**Town of Surfside
PLANNING & ZONING BOARD
AGENDA**

MAY 27, 2021 – 6:00 p.m.

**Town of Surfside
PLANNING & ZONING BOARD
MINUTES
APRIL 29, 2021 – 6:00 p.m.**

NEW LOCATION 88TH ST GATE PLAN

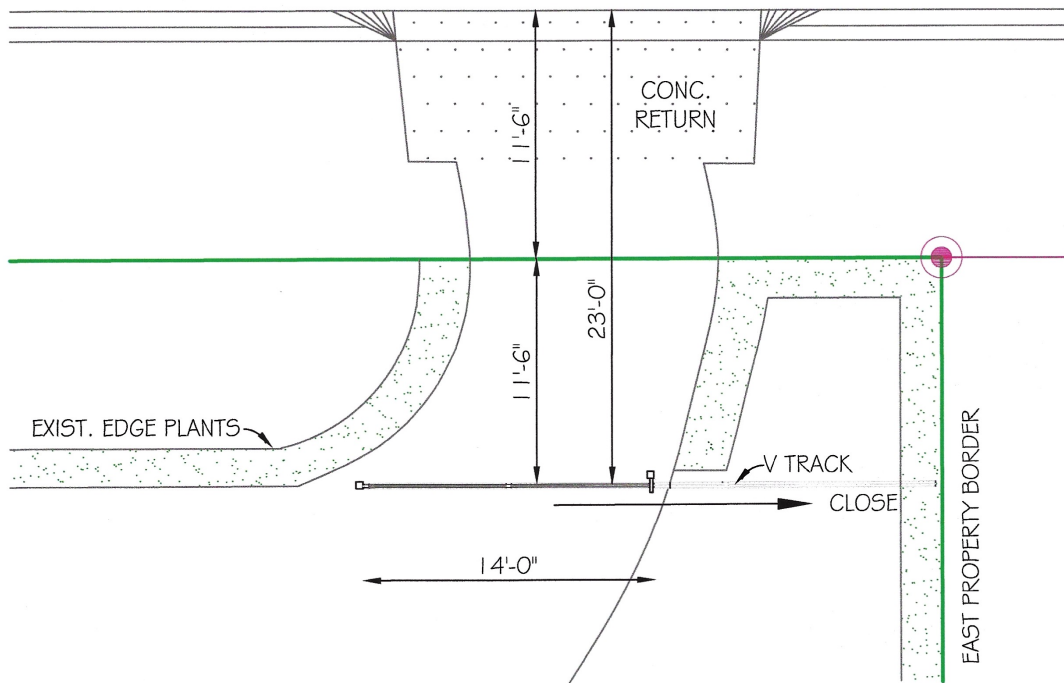
Staff Recommendation: This property has large hedges on both Froude Avenue and on 88th Street. Froude Avenue dead ends north of Biscayne Bay adjacent to this property. Engineered drawings provided by the Applicant indicate the gate on 88th Street is 5 feet high with the upper 3 feet close to 50% transparent. The gate on Froude Avenue is 2 feet 6 inches high and also close to 50% transparent. Staff would recommend the gates be fully 50% transparent. Staff does not have any issues with the driveway gates provided the Planning and Zoning Board gives design approval.
